Maxtor Corporation
500 McCarthy Boulevard
Milpitas, CA 95035 USA

To: T10 SAS Protocol Working Group
Contact: Mark Evans
Phone: 408-894-5310
Email: mark_evans@maxtor.com
Date: 31 October 2003

Subject: SAS-1.1, adding the Terminate Data Transfer protocol service

Figure 1 shows the ST_I state machines.

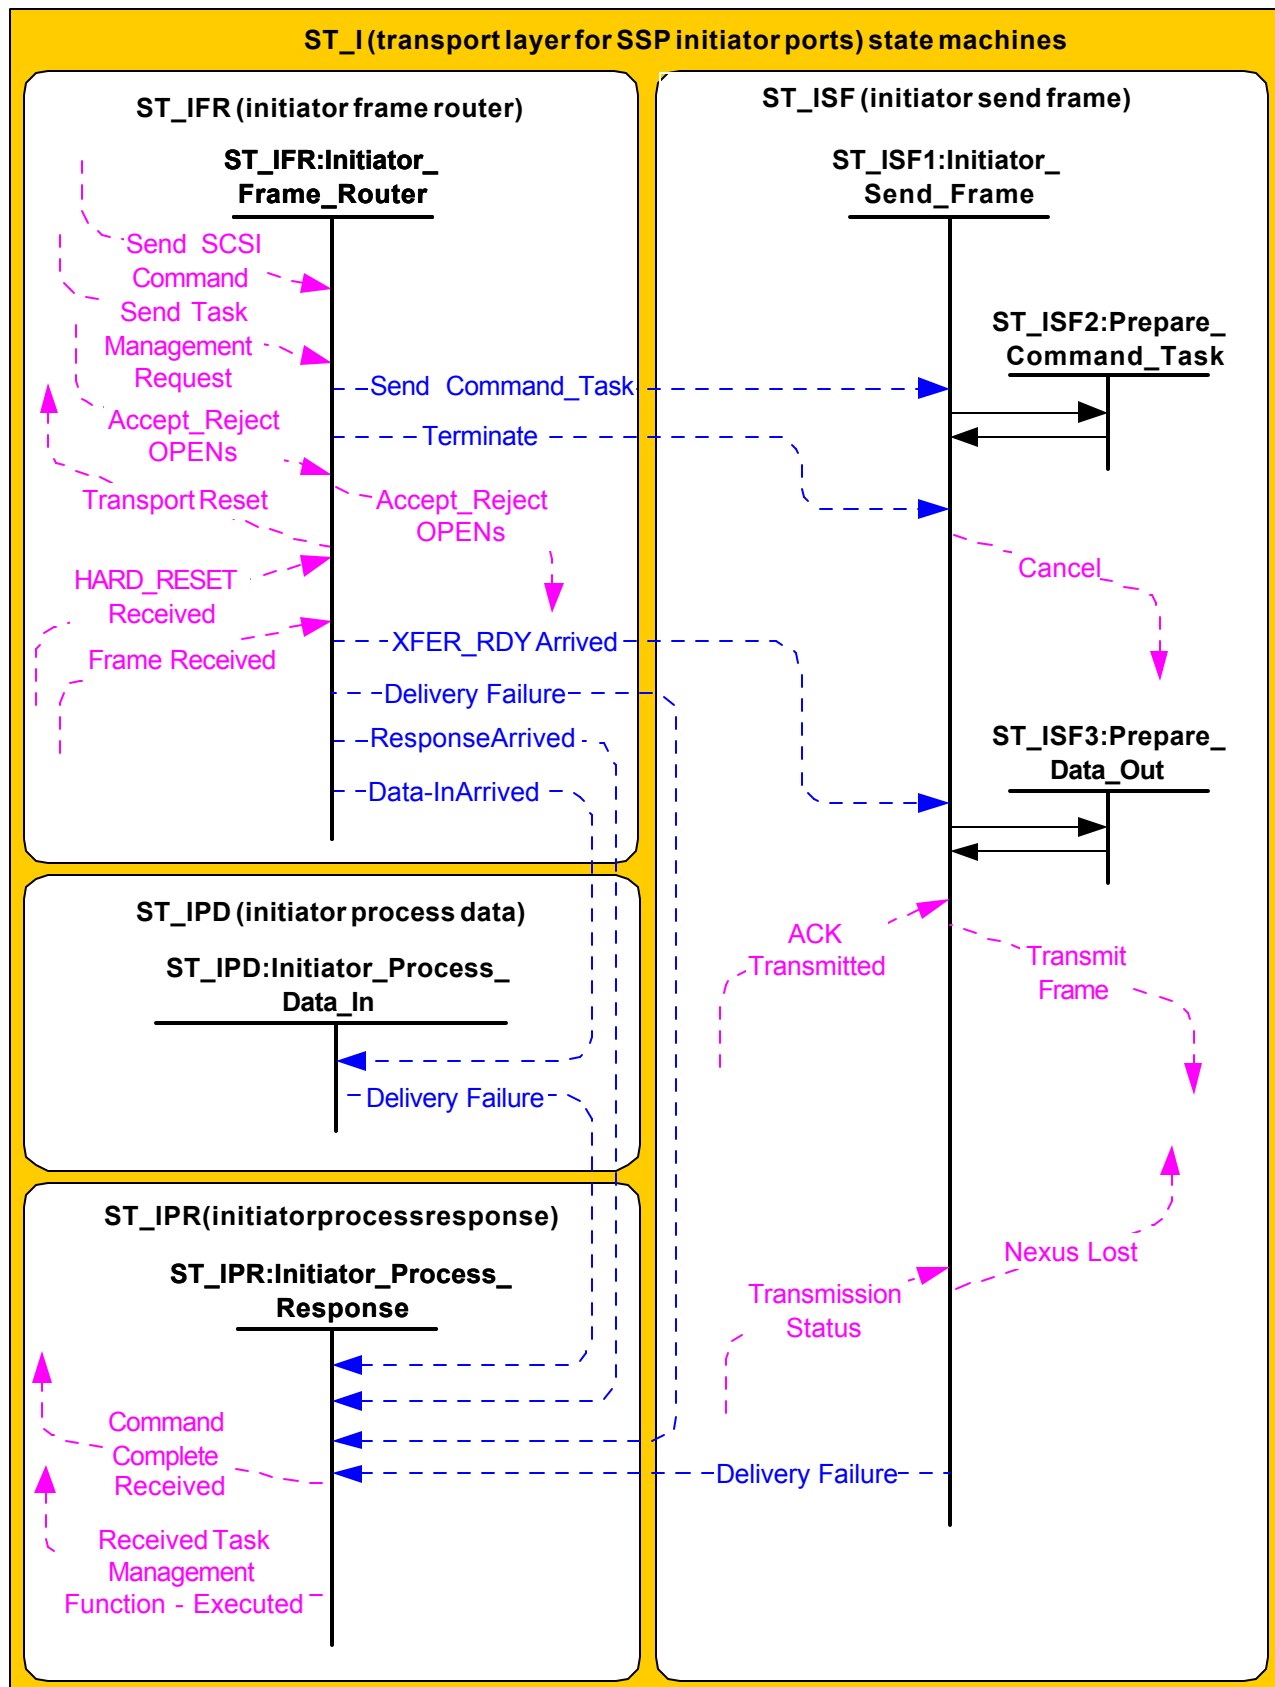
Item 7) In order for tasks to be cleared from SSP initiator ports after a task management request affecting that task has been received, it is necessary for the ST_IFR:Initiator_Frame_Router state machine to be aware of outstanding tasks and task management requests. Because of this, this proposal moves the Send SCSI Command and Send Task Management protocol service requests from being sent to the ST_ISF1:Send_Frame state machine to being sent to the ST_IFR state machine. This makes it so that the flow of the text in the draft standard is better if the ST_IFR description precedes the ST_ISF1 description. The following proposed text makes those changes along with some other editorial changes (note also that the ST_IFR state machine no longer terminates). The following begins with clause 9.2.6.1.

[\[The only change in the following is the order of the list to reflect moving the ST_IFR description.\]](#)

0.0.0.2.2 ST_IFR (initiator frame router) state machine

- a) receives Send SCSI Command and Send Task Management transport protocol service requests from the SCSI application layer;
- b) sends Send Command_Task, Terminate, and XFER_RDY Arrived messages to the ST_ISF state machine;
- c) sends Data-In Arrived messages to the ST_IPD state machine;
- d) sends Response Arrived messages to the ST_IPR state machine;
- e) receives HARD_RESET Received confirmations from the port layer;
- f) sends Transport Reset confirmations to the application layer;
- g) receives Accept_Reject OPENs requests from the SCSI application layer; and
- h) sends Accept_Reject OPENs requests to the port layer.

If this state receives a Send SCSI Command transport protocol service request or a Send Task Management Request transport protocol service request, then this state shall send a Send Command_Task message to an ST_ISF state machine. The message includes the following to be used in any OPEN address frames required to service the request:

If the request is a Send SCSI Command transport protocol service request, and the request causes one or more outstanding tasks in the port to be cleared or aborted (e.g. PREEMPT), then this state shall send a Terminate message to any ISF state machine that is processing one of the affected tasks.

If the request is a Send Task Management Request transport protocol service request, and the request causes one or more outstanding tasks in the port to be cleared or aborted, then this state shall send a Terminate message to any ISF state machine that is processing one of the affected tasks.

Figure 2 — ST_T (transport layer for SSP target ports) state machines

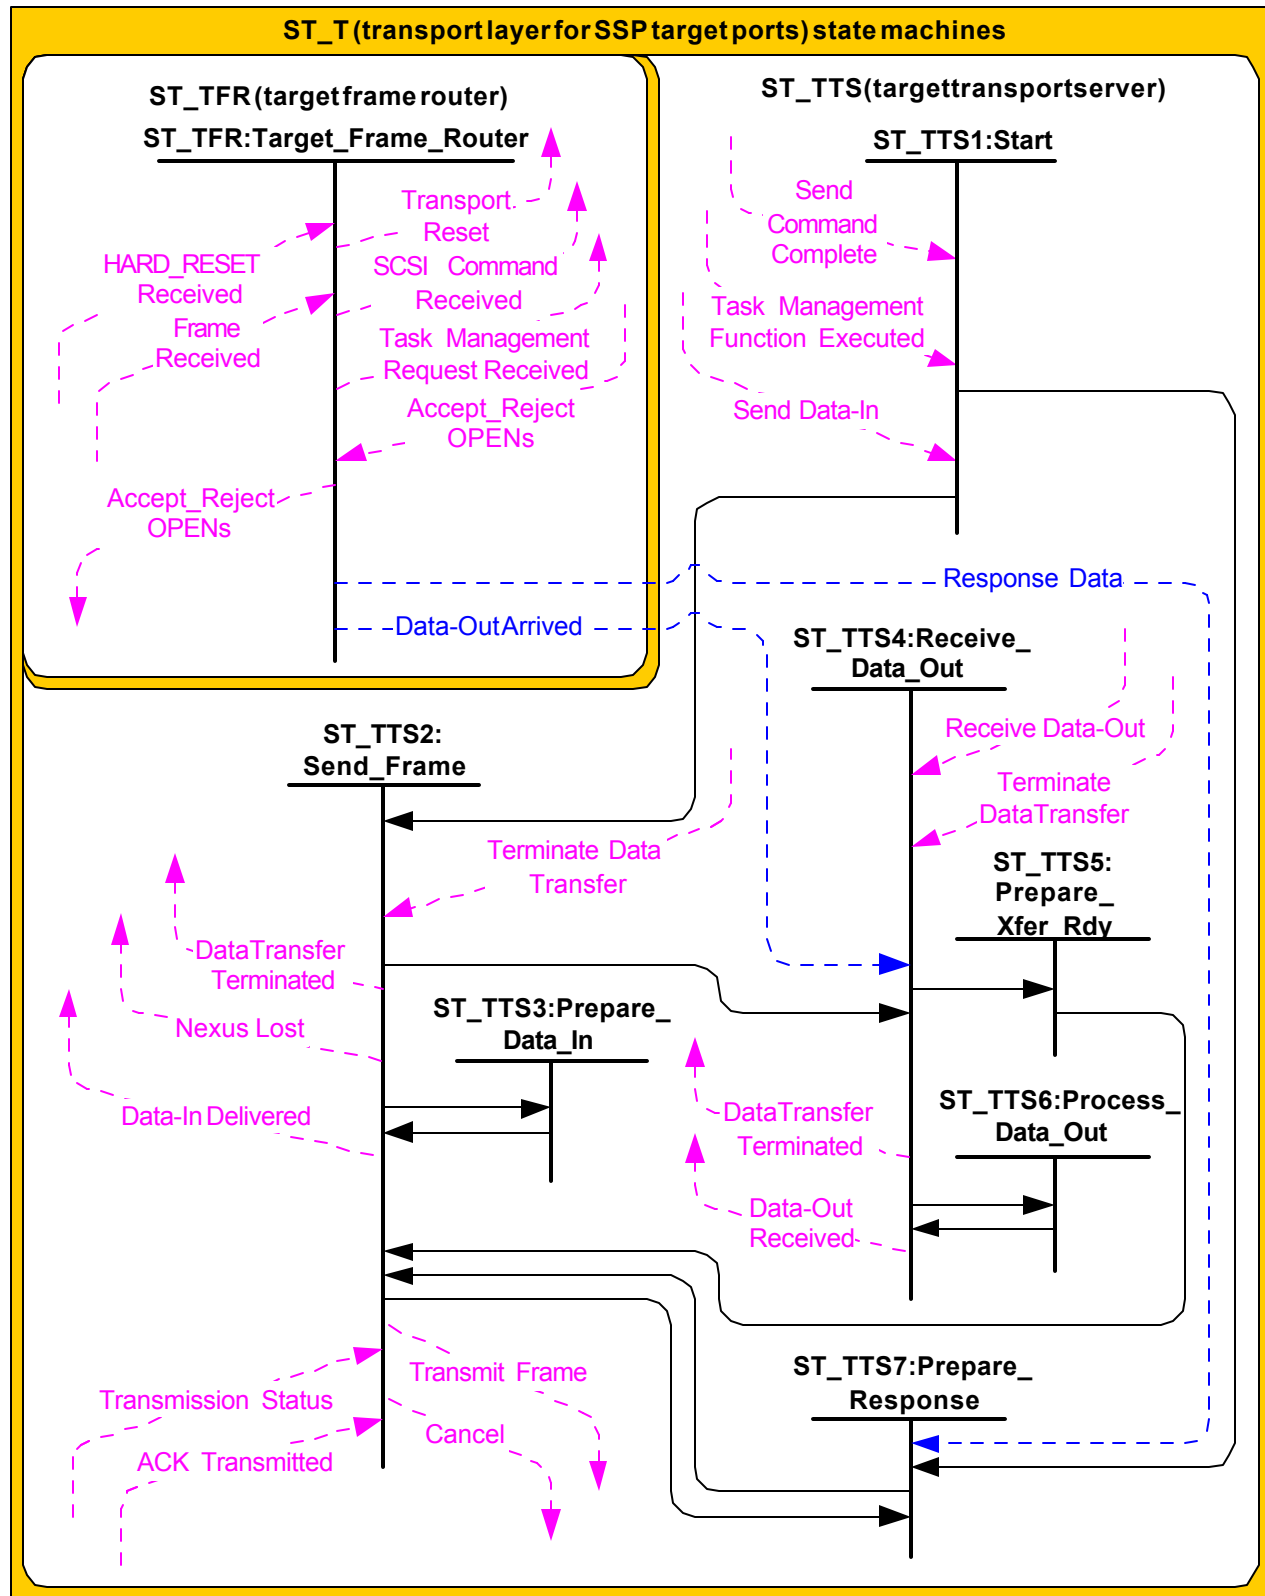
Item 8) In Figure 114 - ST_T (transport layer for SSP target ports) state machines in clause 9.2.6.3.1 ST_T state machines overview add:

- a) a Terminate Data Transfer request from the application layer to ST_TFR:Target_Frame_Router;
- b) a Data Transfer Terminated confirmation from ST_TFR:Target_Frame_Router to the application layer;
- c) a Terminate message from ST_TFR:Target_Frame_Router to ST_TS2:Send_Frame; and
- d) a Terminate message from ST_TFR:Target_Frame_Router to ST_TTS4:Receive_Data_Out.

These changes are shown in the following figure.
